Work Order ID 85314

Item Name: Crosstube Fwd

A	NEW ISSUE	CP	11.07.15
REV.	DESCRIPTION	BY	DATE
DESIGN	90	DART AEROSPACE LTD HAWKESBURY, ONTARIO, CANADA	
DRAWN	90		
CHECKED	ASS	DRAWING NO.	REV. A
MFG. APPR.	N/A	DSI 9565	SHEET 1 OF 1
APPROVED		TITLE	SCALE
DE APPR.		SUPPORT INSTALLATION CHANGE	NTS
DATE	11.07.15	COPYRIGHT © 2011 BY DART AEROSPACE LTD THIS DOCUMENT IS PRIVATE AND CONFIDENTIAL AND IS SUPPLIED ON THE EXPRESS CONDITION THAT IT IS NOT TO BE USED FOR ANY PURPOSE OR COPIED OR COMMUNICATED TO ANY OTHER PERSON WITHOUT WRITTEN PERMISSION FROM DART AEROSPACE LTD.

DRAWING NO. D407-667-145	TITLE CROSSTUBE ASS'Y (407 HIGH FWD)	REV. C	DART AEROSPACE LTD ENGINEERING ORDER		D.E.O. NO. D407-667-145-C-1	SHEET NO. SHEET 1 OF 1	SCALE NTS
DRAWN <i>q</i>	CHECKED <i>ASS</i>	MFG. APPR. <i>AS</i>	APPROVED <i>WD</i>		DE APPR. <i>HA</i>		
DATE 11.07.15	DATE 11.07.22	DATE 11.07.22	DATE 11/07/22		DATE 11.07.21

FIGURE 1 - GROUNDING STRAP INSTALLATION
(VIEW LOOKING FWD)

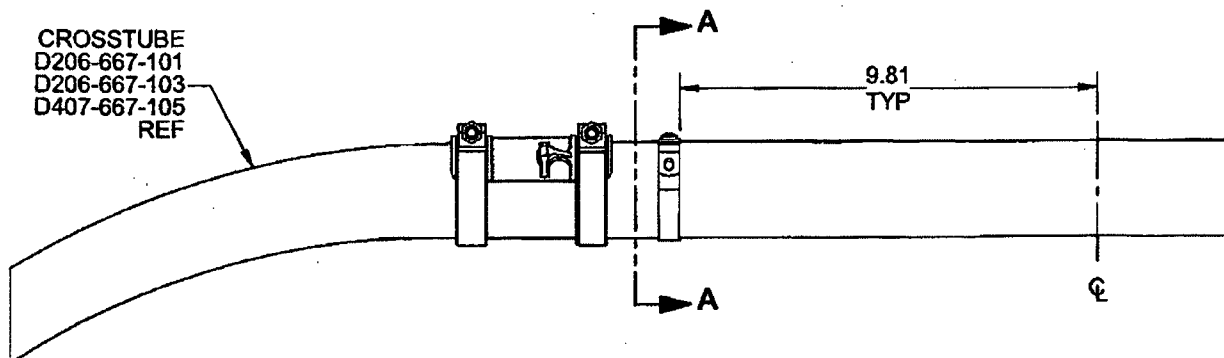
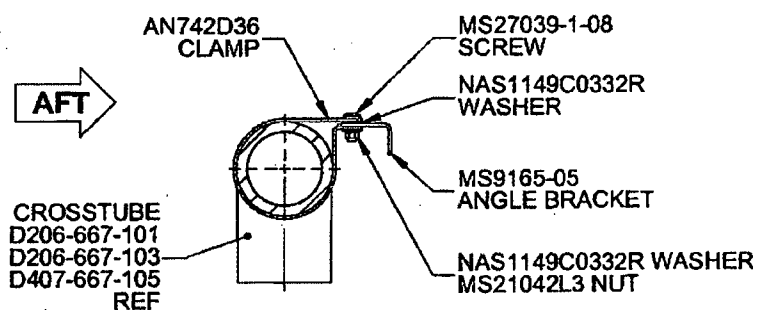
The purpose of this service instruction is to add the optional D206-667-017 Kit and provide guidelines to install extra clamps on D206-667-101/-103 or D407-667-105 forward crosstubes to allow fastening of OEM grounding straps.

- 1) If installed, follow Section 32.1 of ICA-D206-667 for removal of the forward crosstube from the helicopter.
- 2) Locate AN742D36 Clamp as shown in Figure 1 of this service instruction and mark location of clamp on the crosstube.

- 3) Remove crosstube finish (paint and primer) in area where AN742D36 Clamp will be installed and touch up affected area with chemical film material (Alodine 1200 or 1201) per MIL-C-5541.

- 4) Install AN742D36 Clamp complete with MS9165-05 per Section A-A of Figure 1 of this service instruction.
- 5) Touch up paint as required per Item 5.3.3 of ICA-D206-667.
